Moolarben Open Cut 3 Extension – Environmental Impact Statement

Thank you for your e-mail dated 14 November 2022 to the Biodiversity, Conservation and Science Directorate (BCS) inviting comments on the Environmental Impact Statement (EIS) for the Moolarben Open Cut 3 Extension project (the project). BCS and the NSW National Parks and Wildlife Service (NPWS) (hereafter referred to collectively as the Environment and Heritage Group (EHG)) have consulted closely and provide this consolidated response setting out our advice and recommendations for the project.

15 March 2023

Figure 1: Predicted Geological Vibration Damage

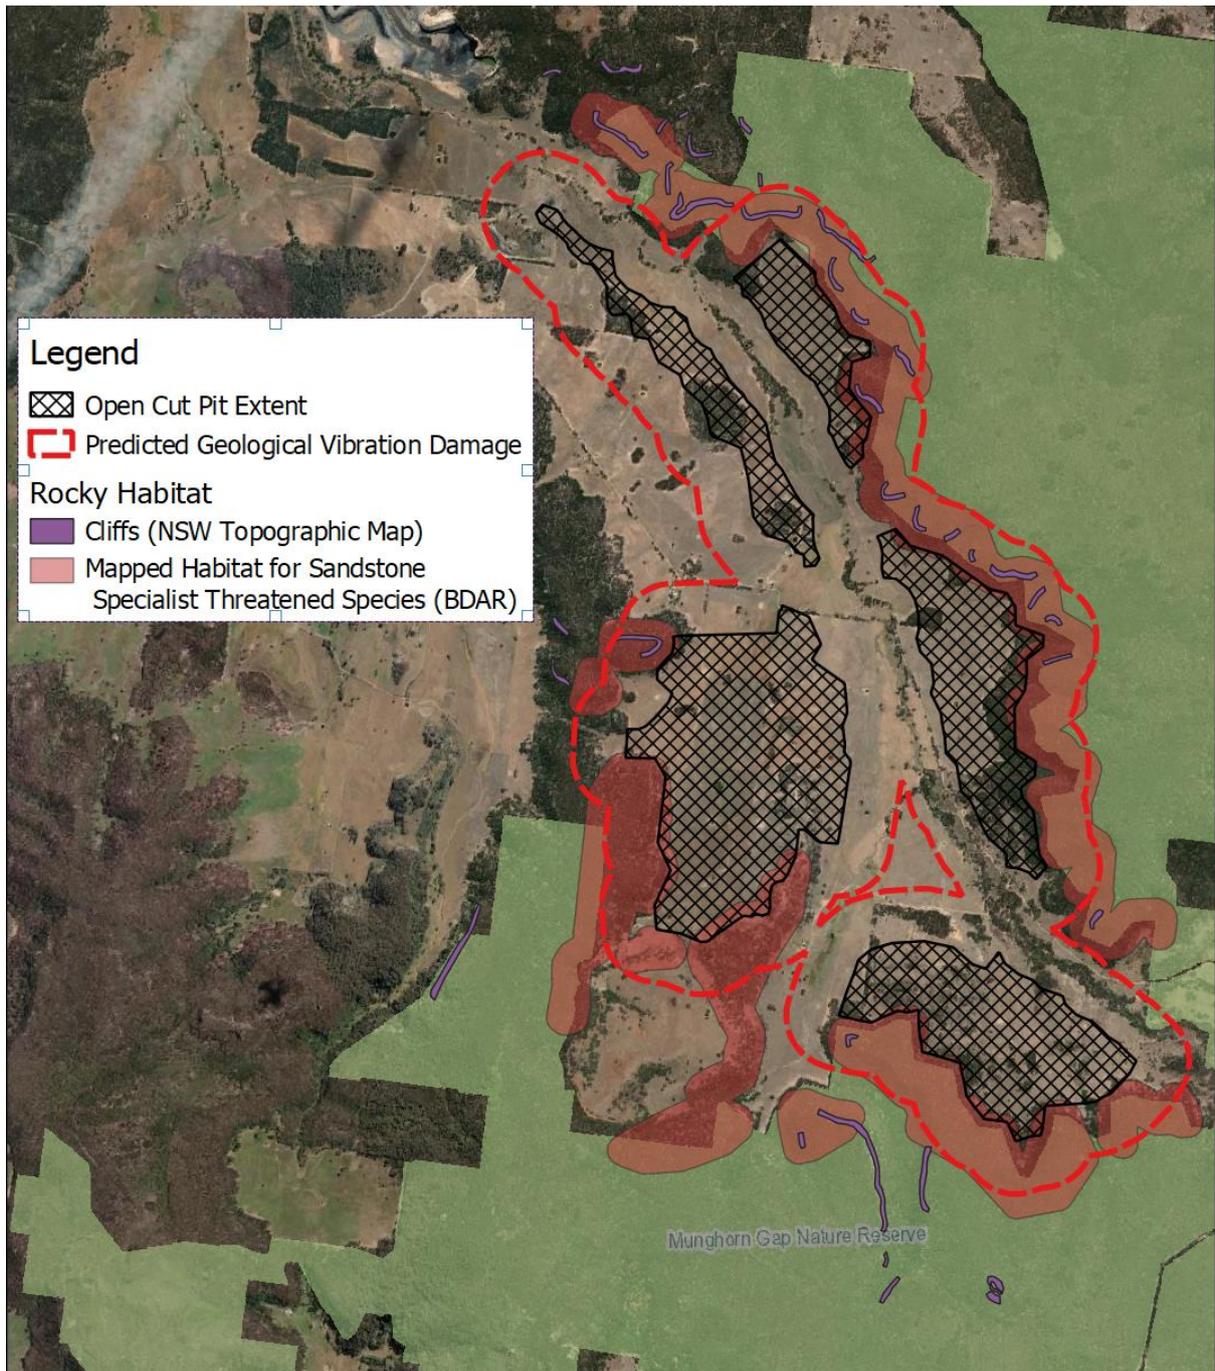
From review of the Blasting Impact Assessment, the maximum distance where the current vibration damage criterion would be exceeded is up to 357 metres away from the project, extending well into the habitats protected by Munghorn Gap Nature Reserve. This has been displayed in Figure 1 below (As stated in Heading 2 below, this total area of vibration impact may be underestimated).

As displayed in Figure 1 of this response, proposed open cut pits will require removal of mapped sandstone habitat for threatened species. This would leave a large extent of connected sandstone habitat immediately adjacent to proposed open cut pits. Given the expected magnitude of potential blast damage for geological features, it is unclear how blasting can be realistically managed such that no additional damage will be caused to threatened species habitat surrounding open cut pits. This is also inclusive of the habitats legislatively protected within Munghorn Gap National Park, which are located approximately 50 metres away or less from proposed open cut pits.

- 1.1. Undertake habitat mapping for sandstone specialist threatened species habitat within the areas likely to receive vibration impacts from blasting. This should be undertaken after a revised damage criterion is established, as recommended in Heading 2.

- 1.4. For areas within NPWS estate that will receive vibration impacts, establish setbacks between open-cut pits and all geological features, such that no impacts are expected to occur. This should be undertaken after a revised damage criterion is established, as recommended in Heading 2.

Figure 4: Threatened species located within the predicted airblast disturbance area (for domesticated livestock)⁴.

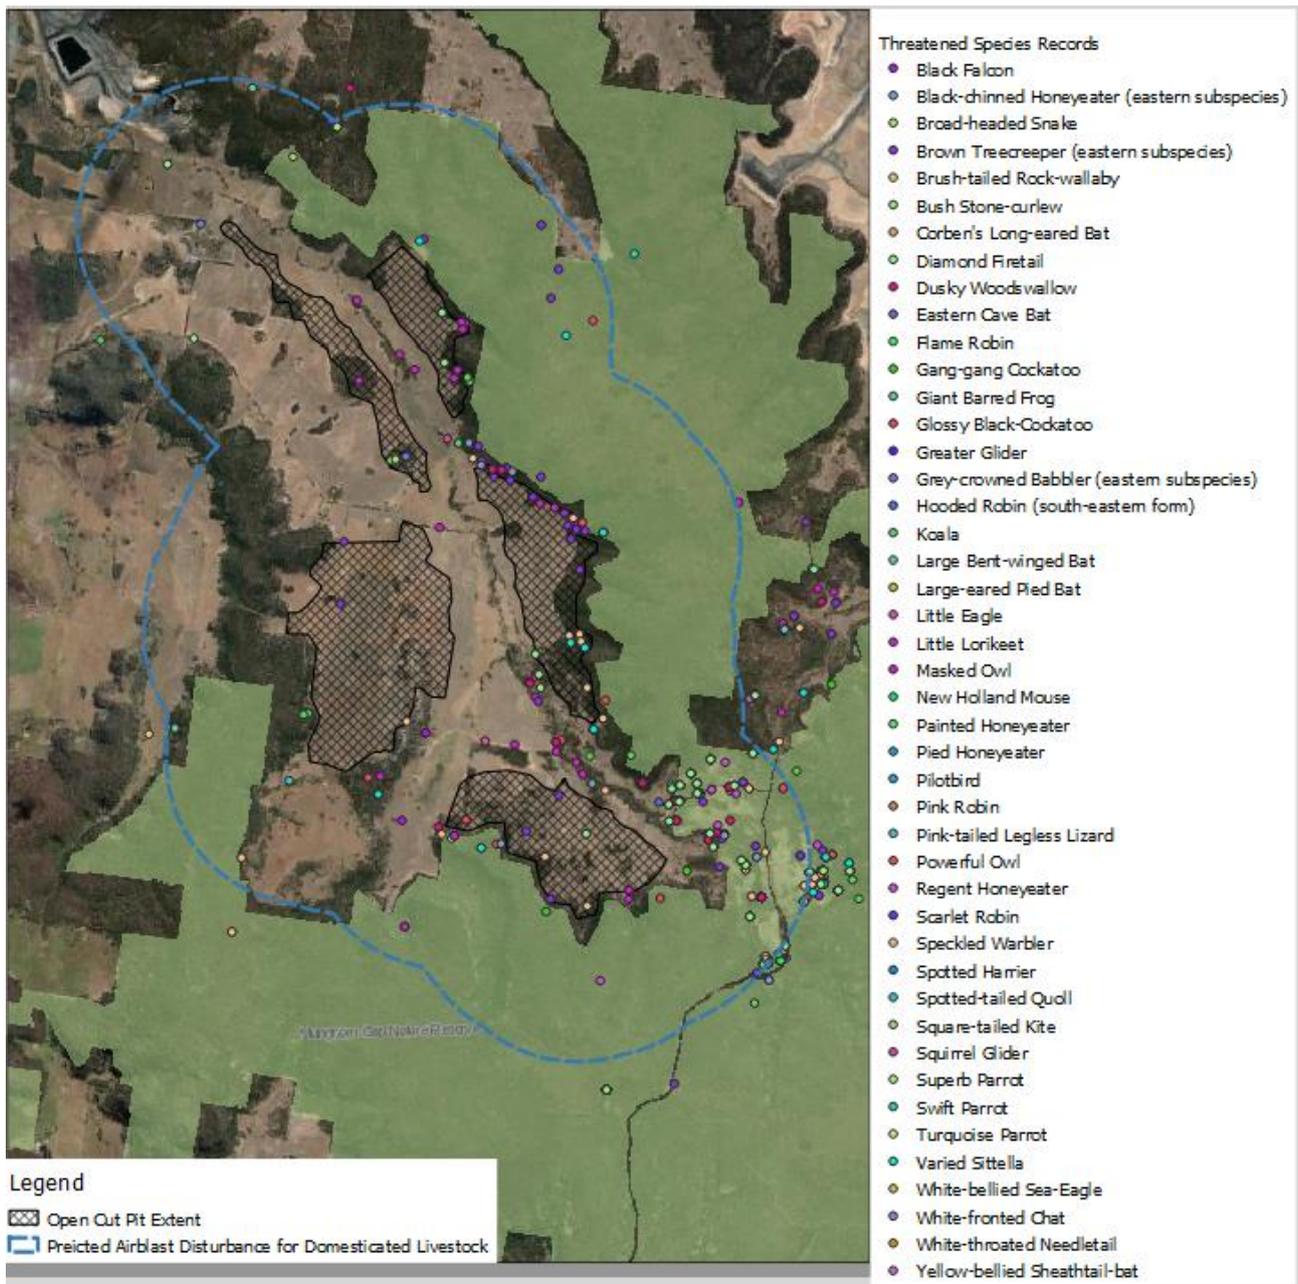
From review of the BioNet Atlas records of threatened species within the vicinity of the project, a high diversity of threatened fauna have been detected within the expected livestock disturbance airblast range. For example, an occupied Masked Owl breeding tree, containing nestlings, was identified by the project ecologists less than 200m from the edge of a proposed blasting area. All threatened species records have also been provided in Figure 4 below.

Of the high diversity of threatened species within the disturbance airblast range, there may be some species that are more sensitive to noise impacts than typical domesticated livestock. As such, there is the potential that the noise disturbance from airblasts to native fauna may reach far greater than what is depicted within Figure 4. As such, an airblast criterion for each taxon of fauna likely to be disturbed by the project i.e., owls, mammals, frogs, woodland birds etc. should be

As displayed in Figure 4, BCS is concerned that the project could disturb at least an additional 2,480 hectares of Important Habitat via operational noise, artificial light and airblast disturbance, including that which is legislatively protected within Munghorn Gap Nature Reserve. Due to the status of the Greater Blue-Mountains Regent Honeyeater population, all future breeding events will be critical to the species on-going survival.

5.1. Describe and justify, in detail, how noise impacts to threatened species and their habitats are expected to be managed during the operation of the project, such that no impacts will occur.

Figure 8: Comparison of aerial imagery from July 2019 to January 2020 on the south-eastern portion of Category 1 land

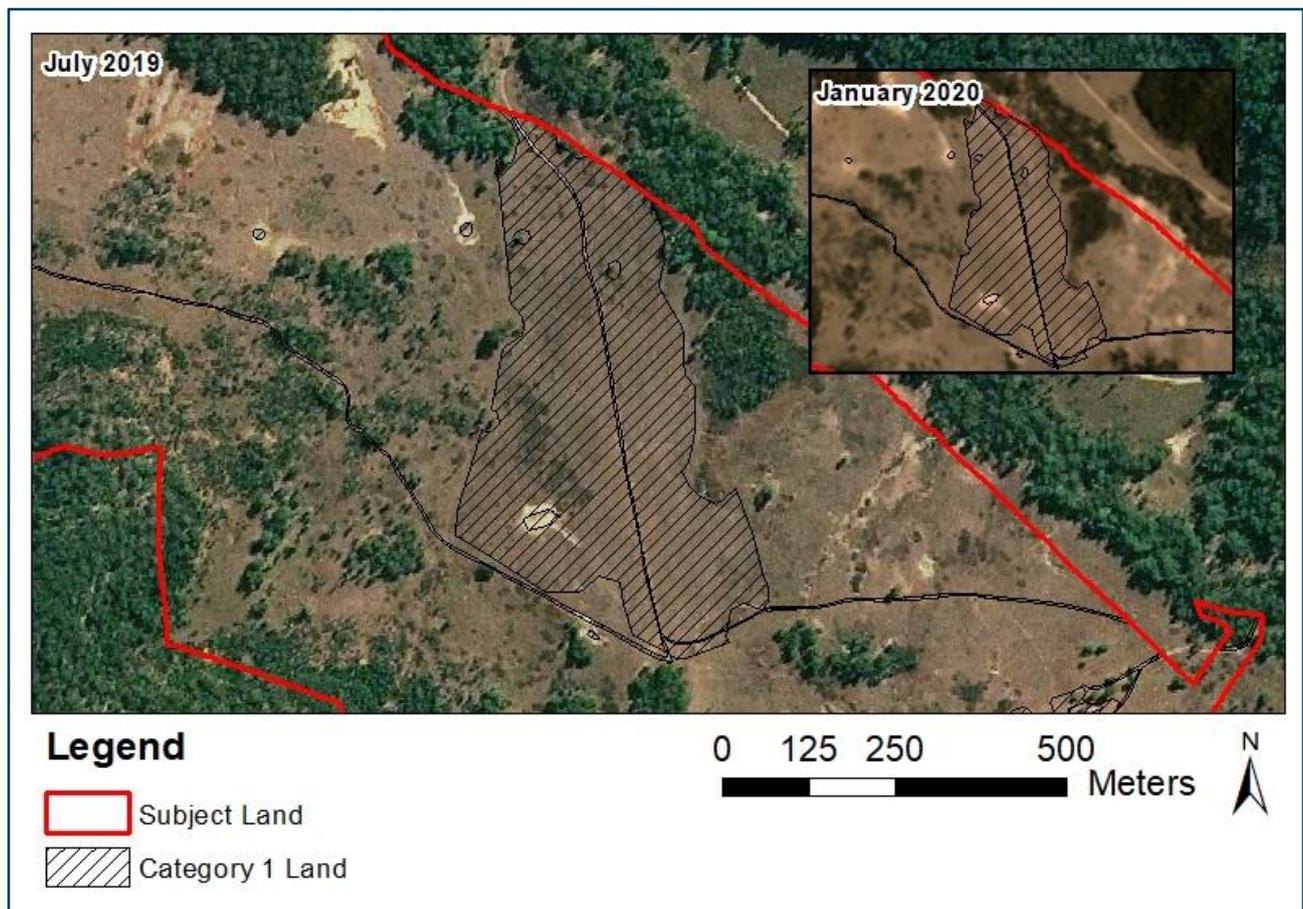
BCS notes field survey for IGGAM plots were undertaken in December 2021 and January 2022. However, there have been no IGGAM or Vegetation Integrity plots across approximately 48ha of the eastern portions of Category 1 land extent. For example, the south-eastern Category 1 land portion shown in Figure 8, appears to only have been field verified by two rapid data points. The data within these plots were not provided to BCS during the submission of the EIS.

Further justification is required that areas of assigned Category 1 land, which do not appear to have received IGGAM survey, have been comprehensively assessed.

- 15.1. Provide additional field verified evidence to support allocation of Category 1 land in areas which do not appear to have received IGGAM survey.
